Product Change Notification / SYST-20FAKY890

ERRATA - PIC18(L)F26/45/46K40 Family Silicon Errata and Data Sheet Clarification Revision

PIC18(L)F26/45/46K40 Family Silicon Errata and Data Sheet Clarification

Figure 1. 28-pin SPDIP, SSOP, SOIC

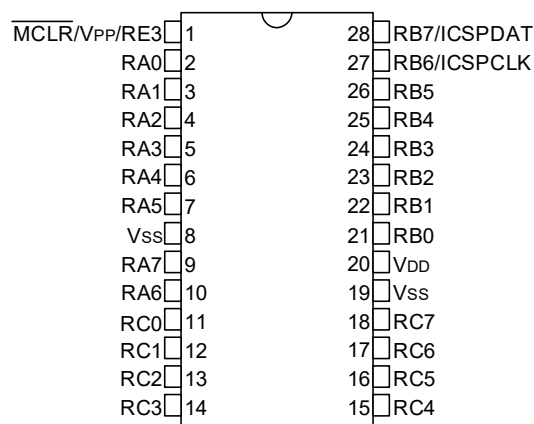
The correct marking for pin 26 on the 28-pin SPDIP/SSOP/SOIC package is **RB5**.

Figure 3. 40-pin PDIP

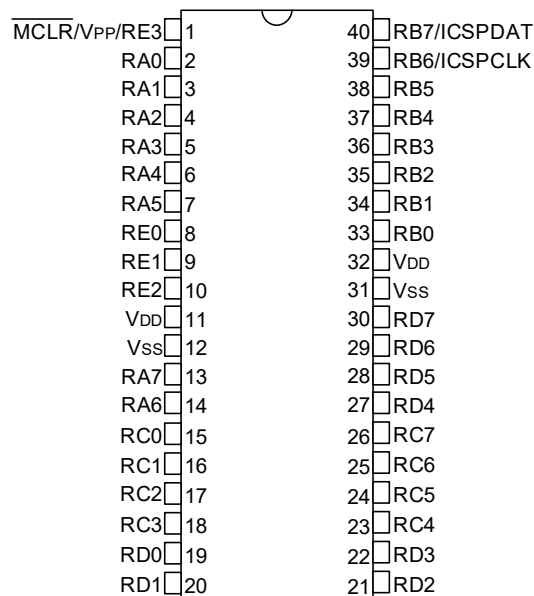
The correct marking for pin 38 on the 40-pin SPDIP package is **RB5**.

Figure 38-10: ADC Conversion Timing (ADC Clock F_{OSC} -Based)

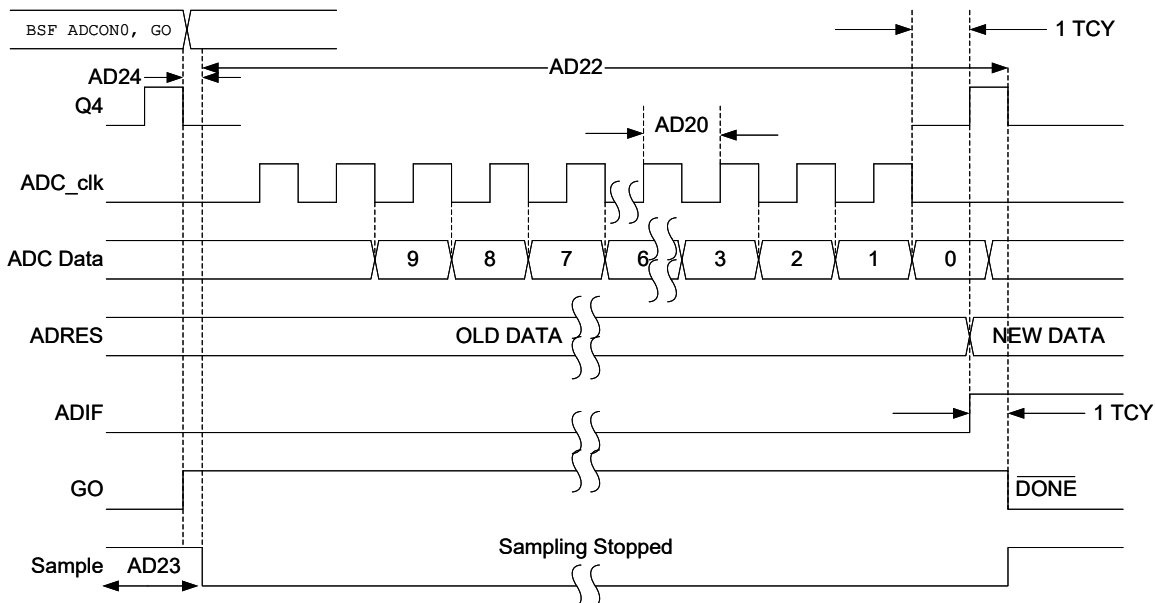
Refer to the images below for corrections of Figure 38-10 and Figure 38-11. Previously, the parameter numbers were incorrect.
